WORKSHOP AGENDA

Planning Commission

May 16, 2023 @ 5:30 PM

Item Title: Site Plan - Seventh Day Adventist Church. Requested by Azimtech, Inc. Property located at 271 Jefferson Pike (Tax Map 18N, Parcel 18.01). R-2 (Medium Density Residential) Zoning District. Property owned by Kentucky/Tennessee Conference of Seventh Day Adventists, Inc.

FINAL EROSION
CONTROL PLAN

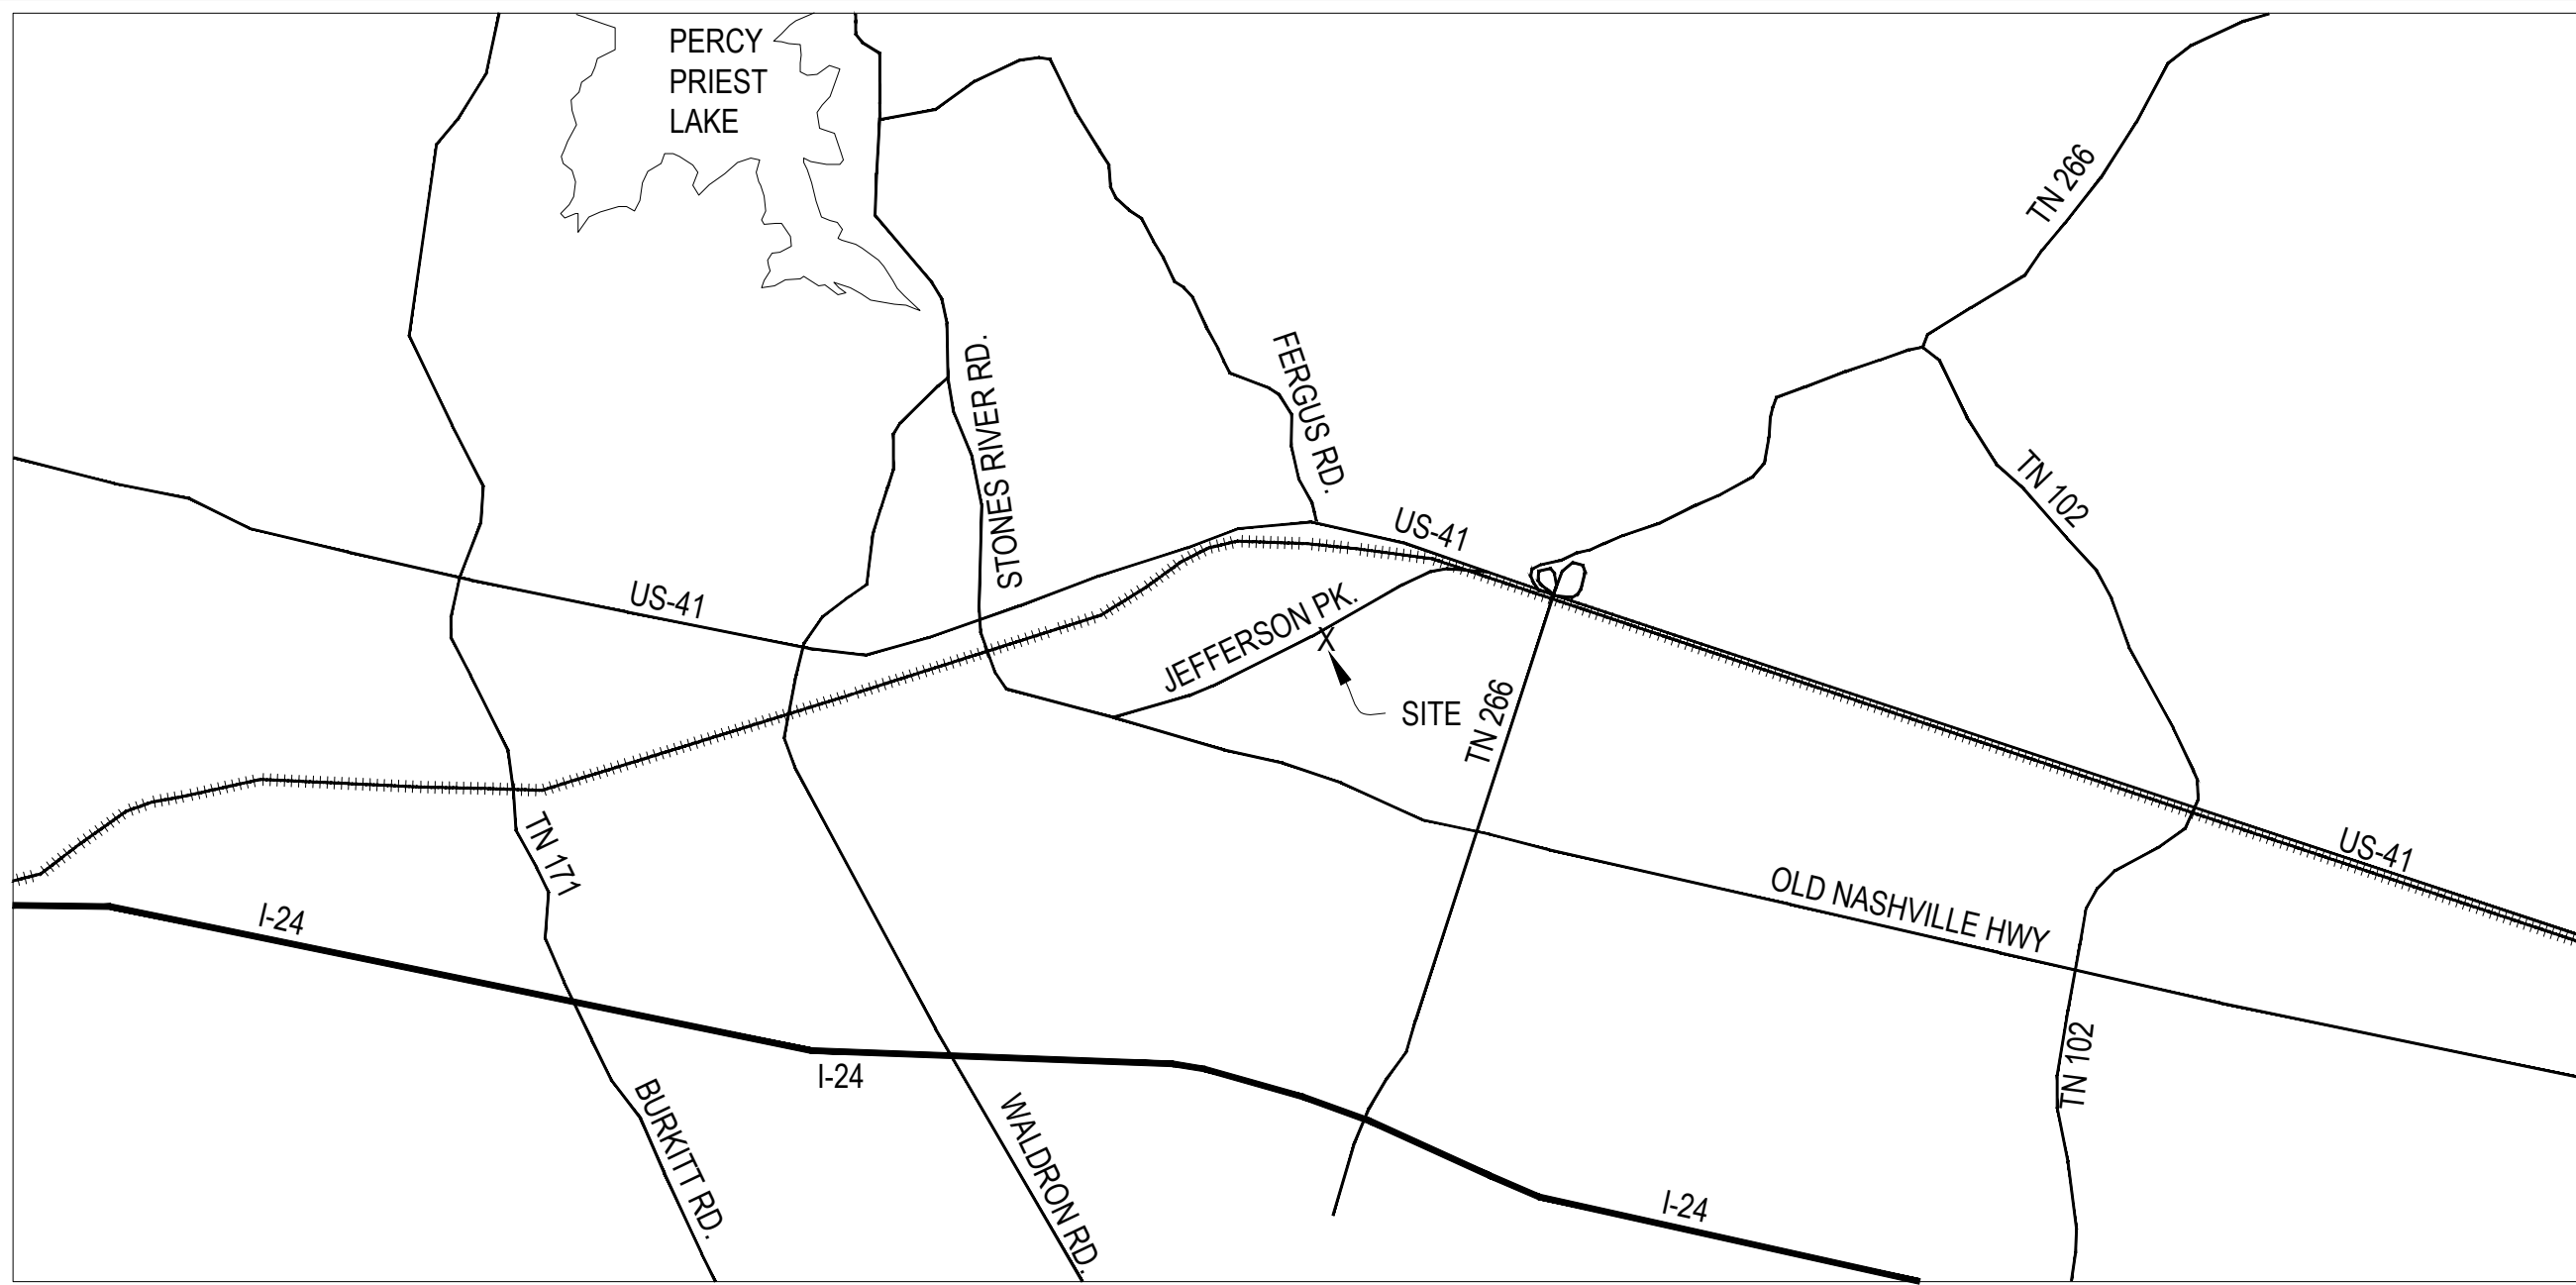
1. (Sheet C2) Please add a note next to the outfall from Detention Pond #1 stating the following:
"Some grading will be required in the public right-of-way to avoid the valve box, communications manhole, power pole and other obstructions. Please provide a small swale which directs the water into the culvert under the next downstream driveway so that water does not travel along the edge of pave of Jefferson Pike."
2. (Sheet C2) Please add a note next to the outfall from Detention Pond #2 stating the following:
"Shape the rock riprap basin as a 'bowl' in order to

Sheet C0.0
Arbor Ridge
Section 4, 5, 9A, & 10
Preliminary Plat & Construction Drawings
S.E.C. Project #18314
Date: 4-24-2023
Revised:

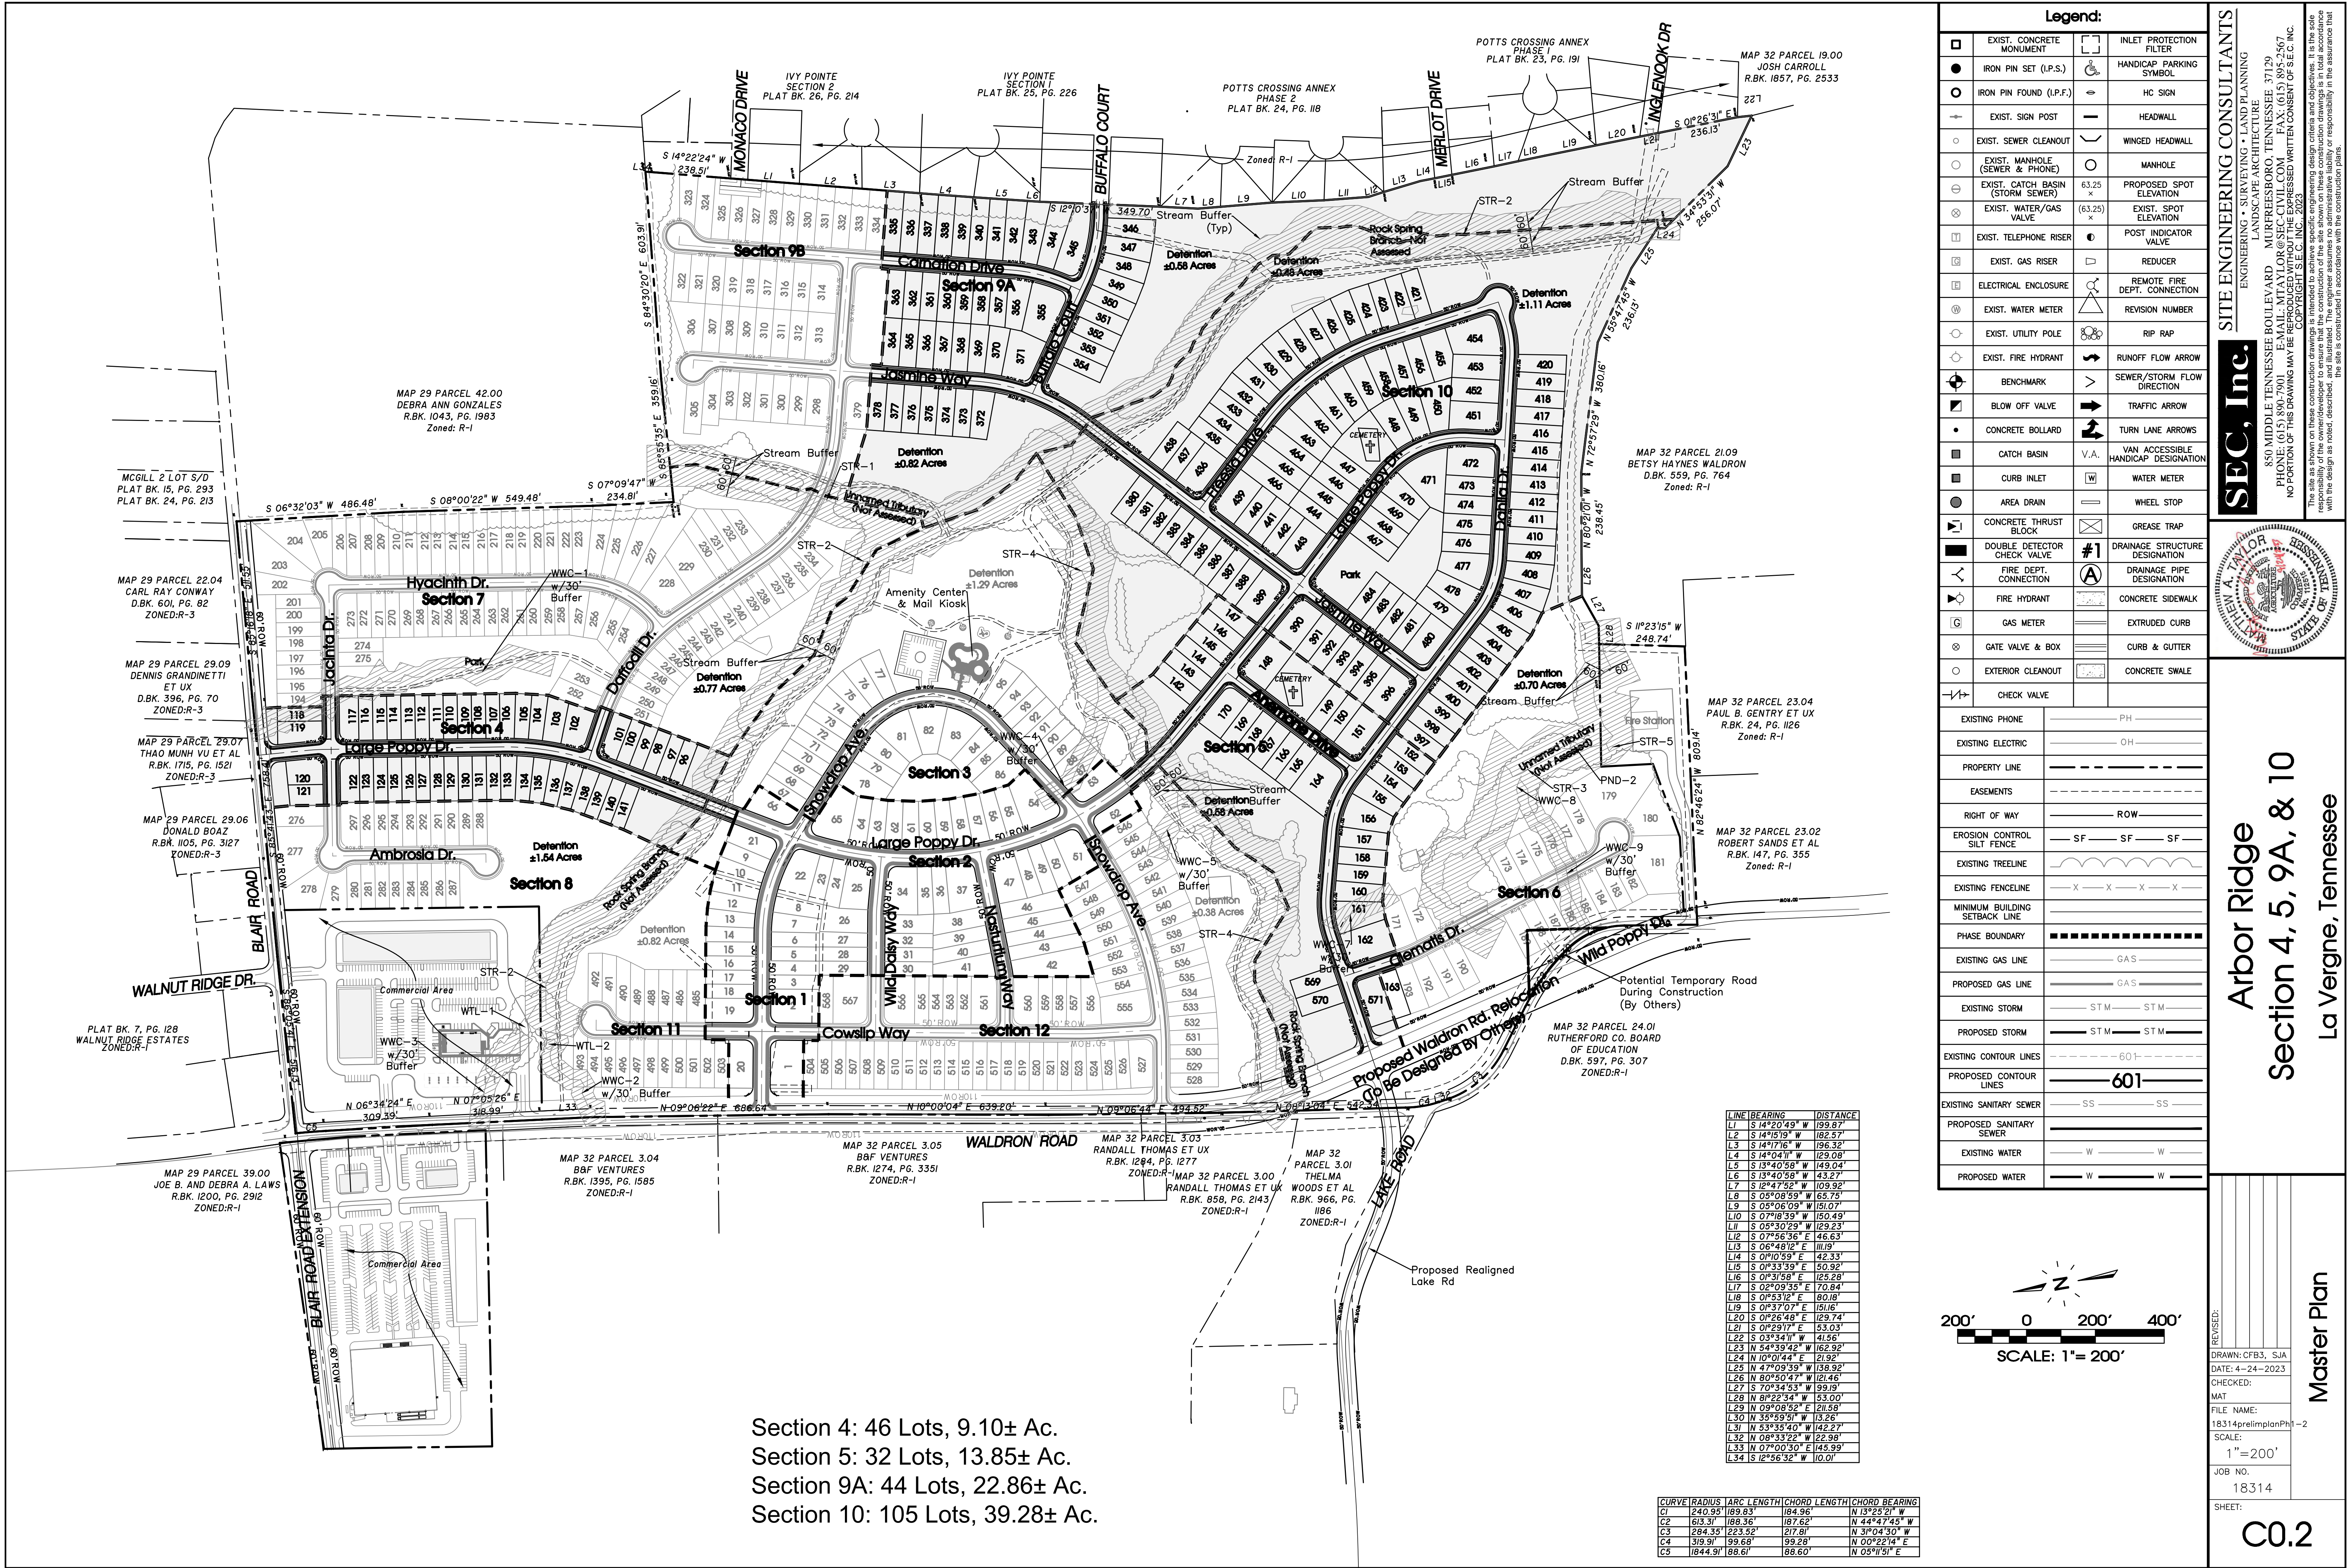
4. (All drawings) Provide contour labeling.
5. Lots 144, 145, 167, 168, 169, 170, 436, 443, 463, 464, and 465 are critical lots. Please mark them with an asterisk.
6. (C1.0) Please provide more detailed information for culvert crossing between Section 3 and 4 including with which section the permanent culvert is intended to be constructed.
7. (All drawings) please confirm if the design intent is for electrical and gas utilities to be in the right-of-way.
8. Per SubRegs 3-102.2/24, please provide landscaping plans.
9. Per SubRegs 3-102.2/25, please show slopes with between 12-20% slopes with general soil types. And separately show slopes 20% and greater.
10. Per SubRegs 3-102.2/27, please show and explain drainage easements required.
